REMARKS

AMENDED MARKED-UP DRAWINGS
SHOWING CHANGES MADE

U.S. Patent Application No. 10/685,009

Entitled: IMPROVED VEHICLE COMPONENT
CENTERING SYSTEM FOR VEHICLE SERVICE DEVICES

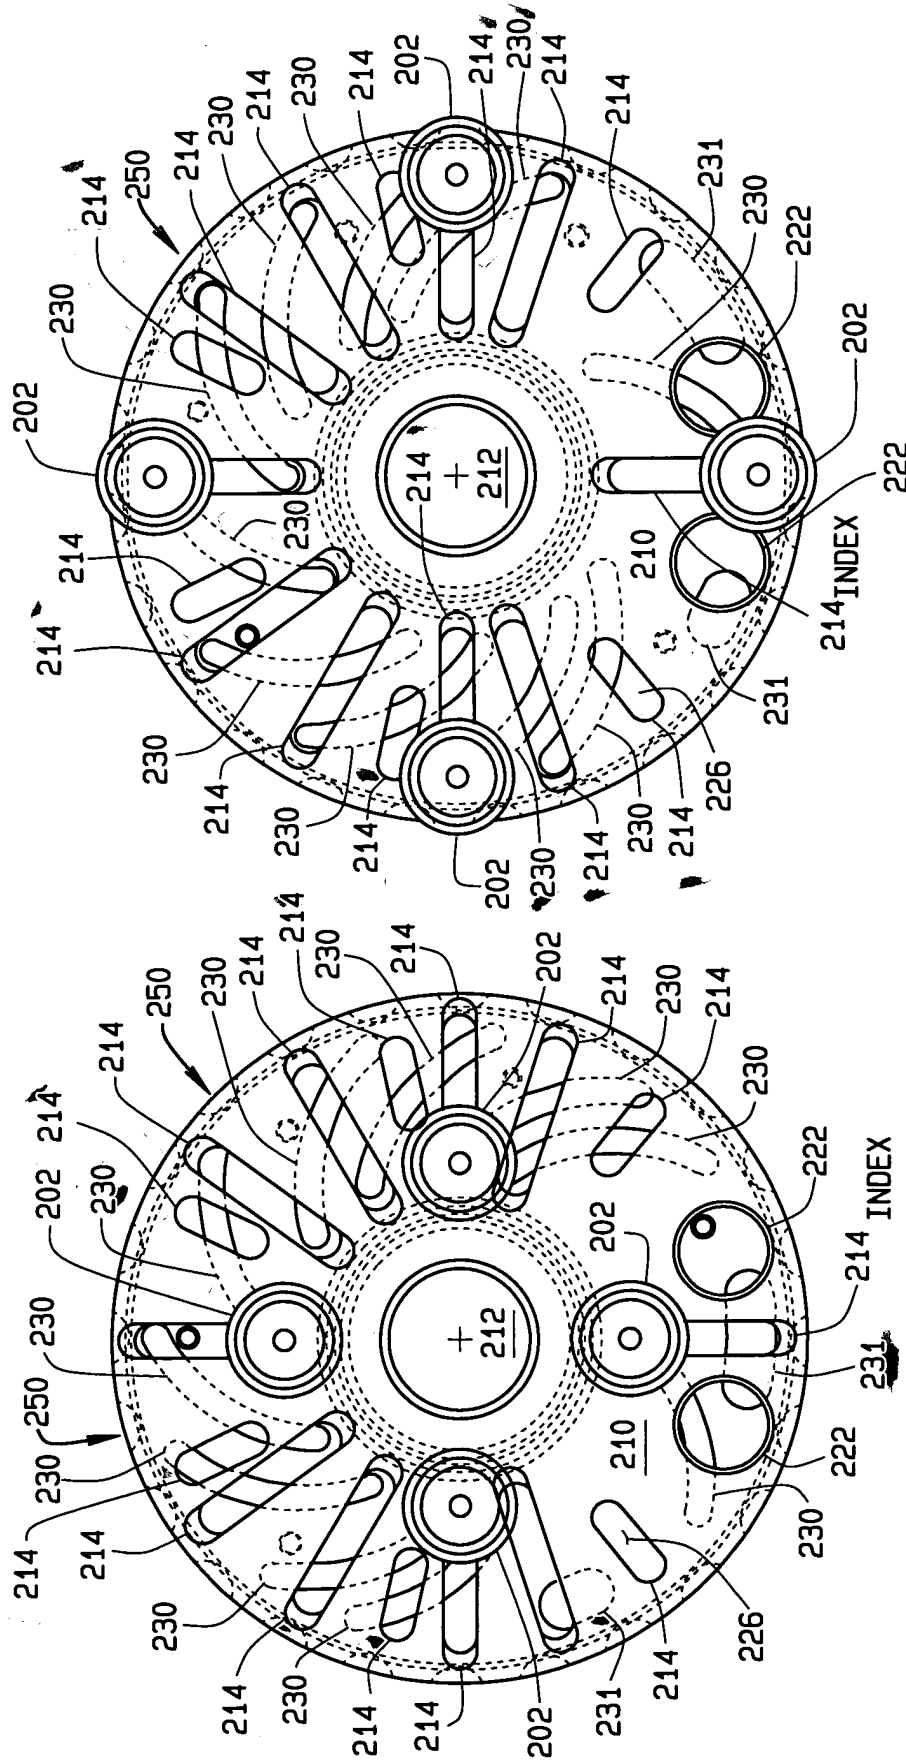
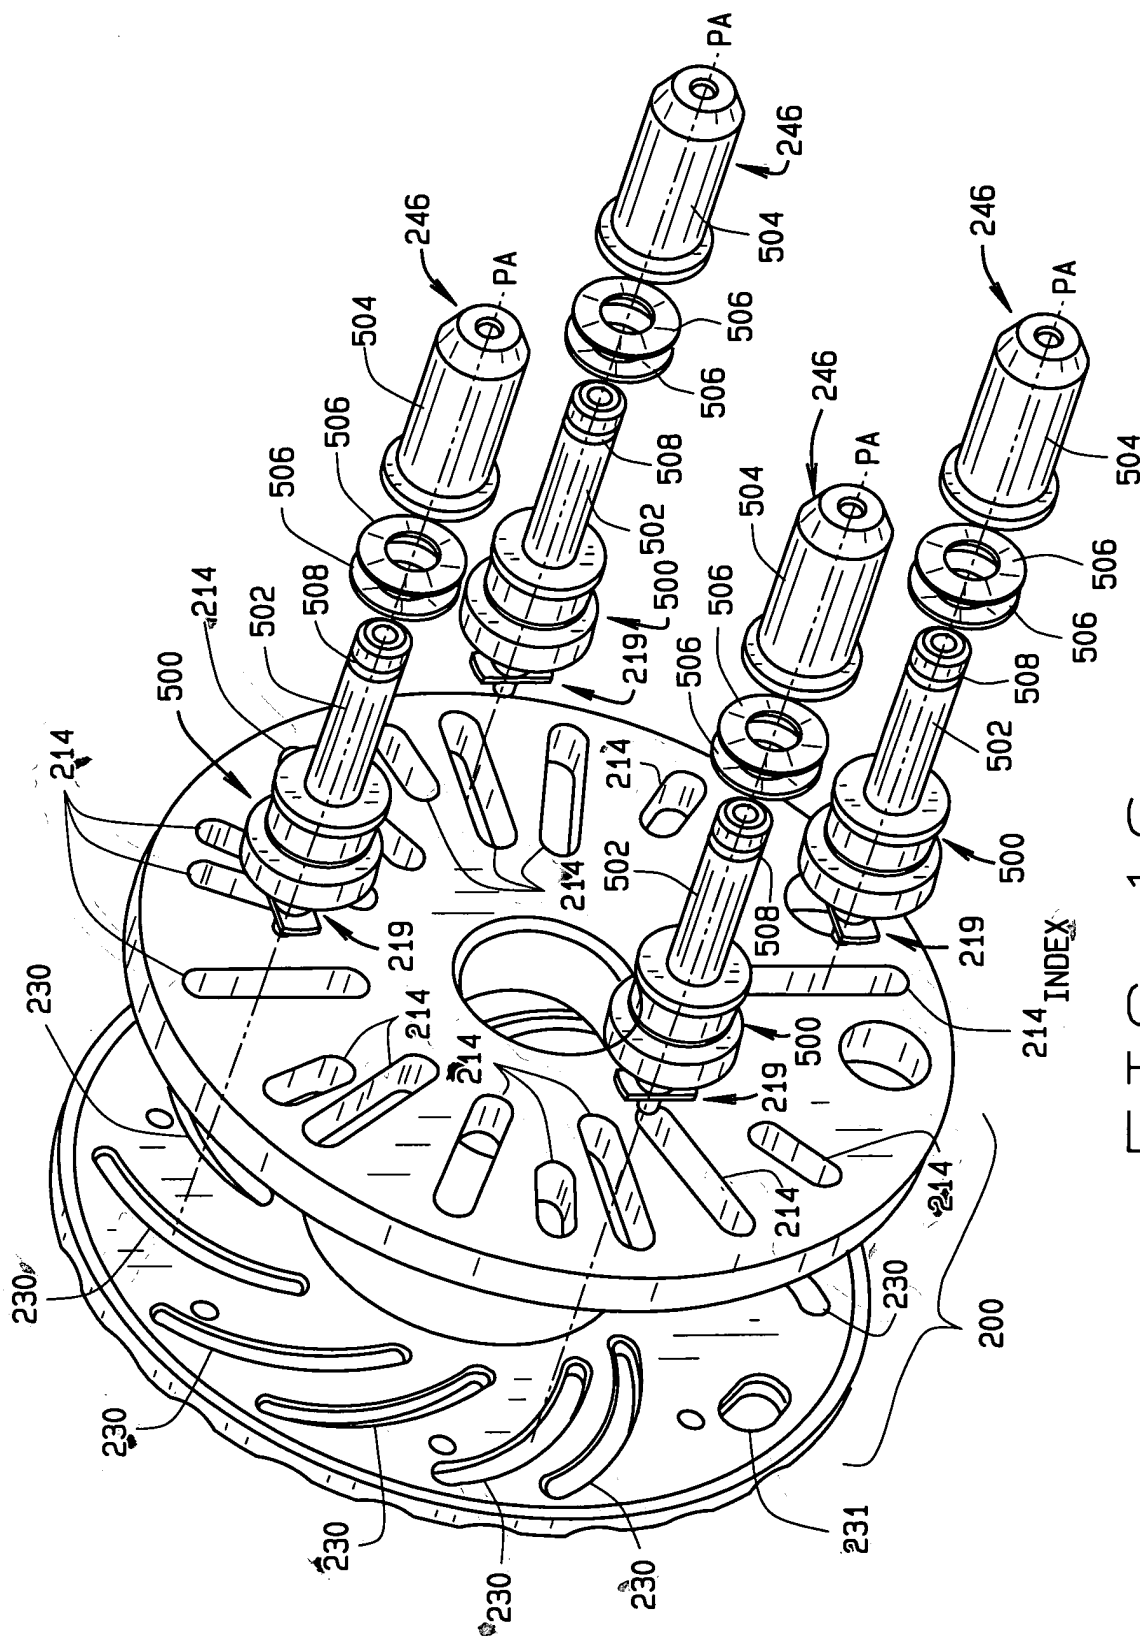
The Examiner has objected to the drawings under 37 CFR 1.83(a) as failing to show every feature of the invention specified in the claims. Specifically, the Examiner has stated that identifying indicia must be associated with *each of the slots*, or the features cancelled from the claims.

The drawings have been amended such that an identifying indicia is associated with each illustrated slot. Specifically, additional identifying indicia have been added to Figures 7A, 7B, and 16 where appropriate to identify unlabelled slots. A clean set of the amended drawings and a marked up set illustrating the changes made have been provided.
